**THERMO KING**

SIZE A3	CODE IDENT NO -	DWG NO 3E97558	REV E
SCALE: NONE		REF DWG: -	SHEET 3 OF 4

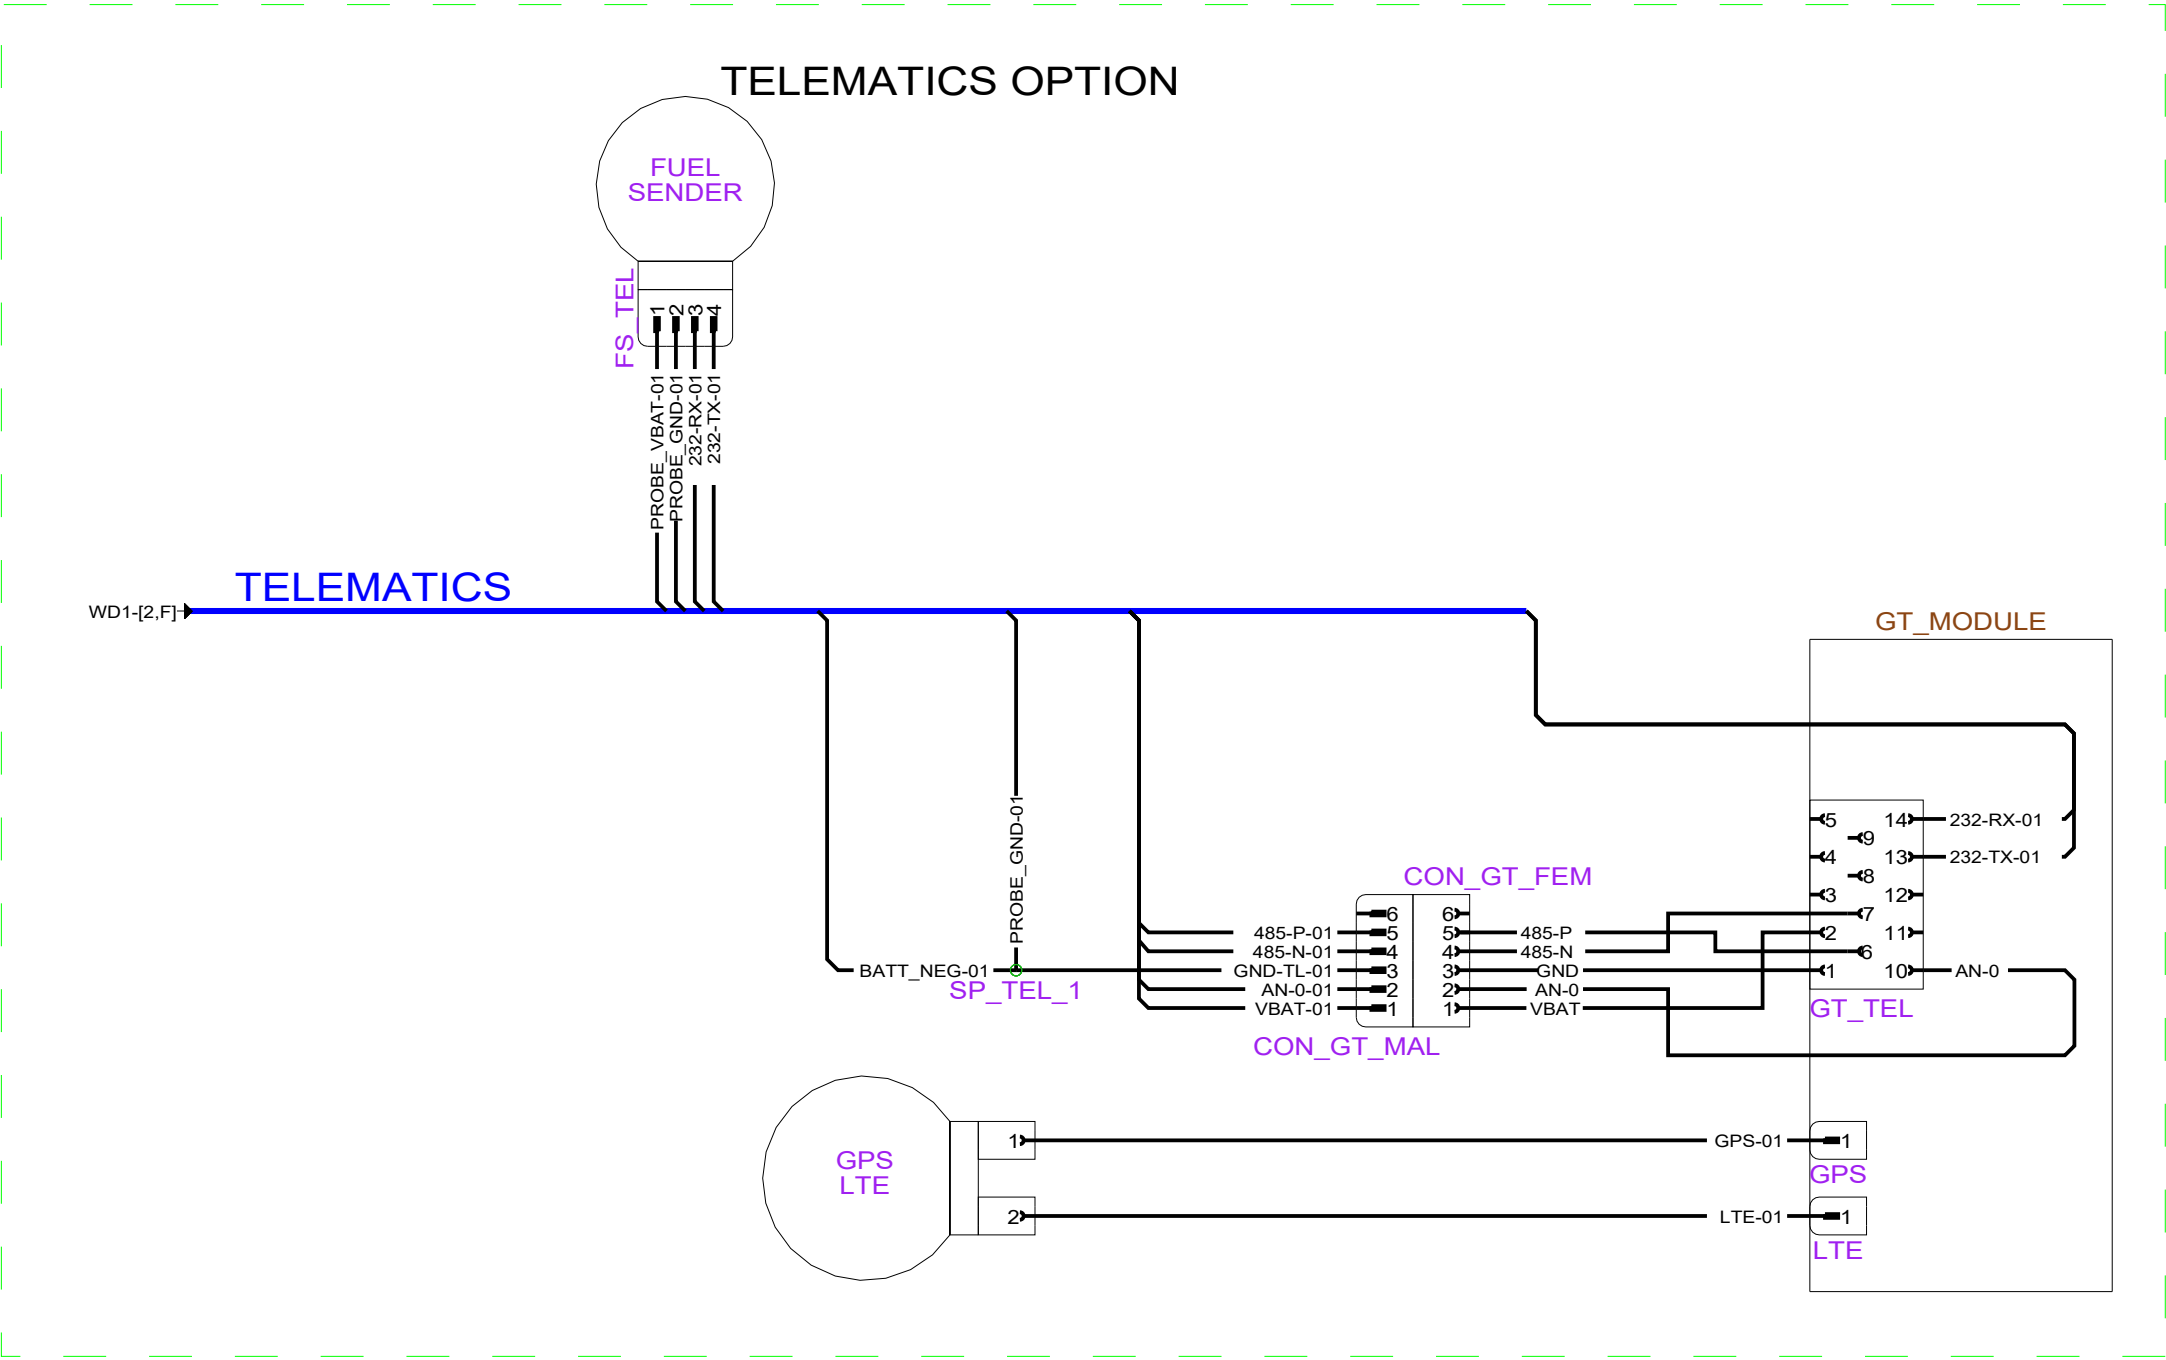
REVISIONS				
CHANGE NOTICE	REV	DESCRIPTION	DATE	APPROVED
1477136	A	INITIAL RELEASE	22/12/20	R.BURNHAM
1509916	B	CHANGE RED-01 FROM STR 87 TO MAIN 87	17/09/21	J.FERREIRA
1515519	C	CHANGE 485-N-01 FROM CTRL-2-10 TO CTRL-2-11,485-P-01 FROM CTRL-2-11 TO CTRL-2-10 REPLACE GND_OLS WITH OLS_2 AND CONNECT TO BAT-POST-06,ADD WIFP-01 FROM CTRL-3-3 TO SW-POST-06, ADD SW-POST-05, ADD CHARGER RELAY,TELEMATICS CONNECTOR,WIRE PWR	11/11/21	R.CAMELL
1523195	E	CHANGE OLS-02 FROM BAT-POST-06 TO 16_GND_LUG, DELETE BAT_CHG_LV CONNECTORS & UPDATE ITS WIRING. CHANGE BATT_POS-02 FROM SW_POST_BAT TO BAT-POST-06	06/04/22	R.CAMELL
